Work Order ID 132234

Item ID: D2731-7 Accept ***N9000040100*** Setup Start ***NS1***
 Revision ID: Stop ***NS2***
 Item Name: Mounting Lug *24*
 Start Date: 5/4/2015 Start Qty: *10.00* ***10*** Cust Item ID:
 Required Date: 5/4/2015 Req'd Qty: *10.00* ***10*** Customer:
 Reference:

DRAWING NO. D2731	TITLE MOUNTING LUG	REV. C	DART AEROSPACE USA, INC ENGINEERING ORDER		D.E.O. NO. D2731-C-1	SHEET NO. SHEET 1 OF 1	SCALE NTS
DRAWN JP	CHECKED SC	MFG. APPR. MA	APPROVED MD		DE APPR. TH		
DATE 11.05.02	DATE 11.05.09	DATE 11.05.09	DATE 11.05.09		DATE 11.05.09

ADD D2731-xRG OPTION

SECTION D-D D4-5
SCALE 2X

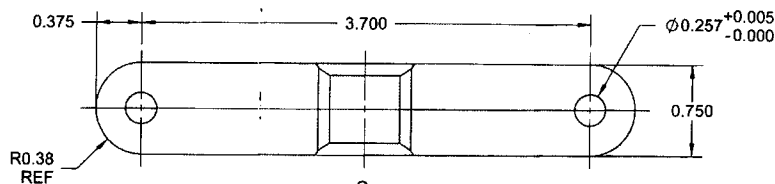
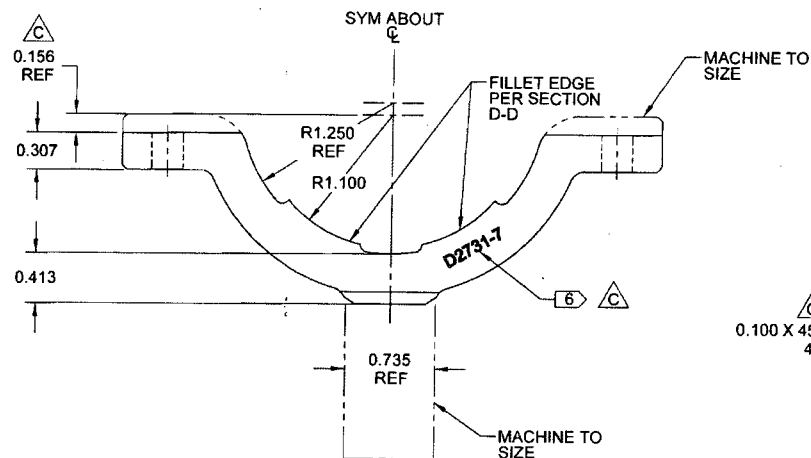
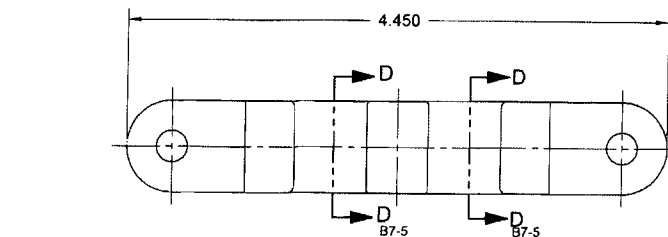
C	REDRAWN IN SOLIDWORKS TO CURRENT DESIGN STANDARDS. REFER TO SECTION A-A, B-B, C-C & D-D FILLET ADDED TO PREVENT CHAFING OF RUBBER CUSHION ON INSTALLATION.	AJS	09.01.19
B	REVISED DIMENSIONS	KE	99.07.06
A	NEW ISSUE	KE	98.05.13
REV.	DESCRIPTION	BY	DATE
DESIGN	KE	DART AEROSPACE USA, INC. PORT HADLOCK, WA	
DRAWN	AJS	DRAWING NO.	REV. C
CHECKED		D2731	SHEET 1 OF 5
MFG. APPR.		TITLE	SCALE
APPROVED		MOUNTING LUG	NTS
DE APPR.		COPYRIGHT © 1998 BY DART AEROSPACE USA, INC. THIS DOCUMENT IS PRIVATE AND CONFIDENTIAL AND IS SUPPLIED ON THE EXPRESS CONDITION THAT IT IS NOT TO BE USED FOR ANY PURPOSE OR COPIED OR COMMUNICATED TO ANY OTHER PERSON WITHOUT WRITTEN PERMISSION FROM DART AEROSPACE USA, INC.	
DATE	09.01.19

D2731-1RG MOUNTING LUG (SHOWN)
D2731-3RG/-5RG/-7RG MOUNTING LUGS (SIMILAR)

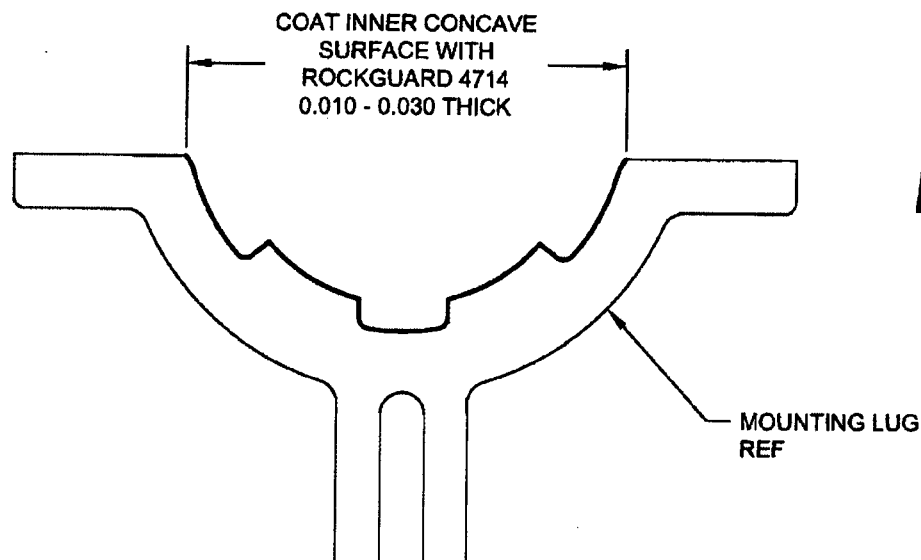
D2731-xRG MOUNTING LUGS ARE INDENTICAL TO D2731-x MOUNTING LUGS, HOWEVER AFTER FINISH, COAT INNER CONCAVE SURFACE WITH "PLUS ONE ROCKGUARD 4714" AS SHOWN BELOW.
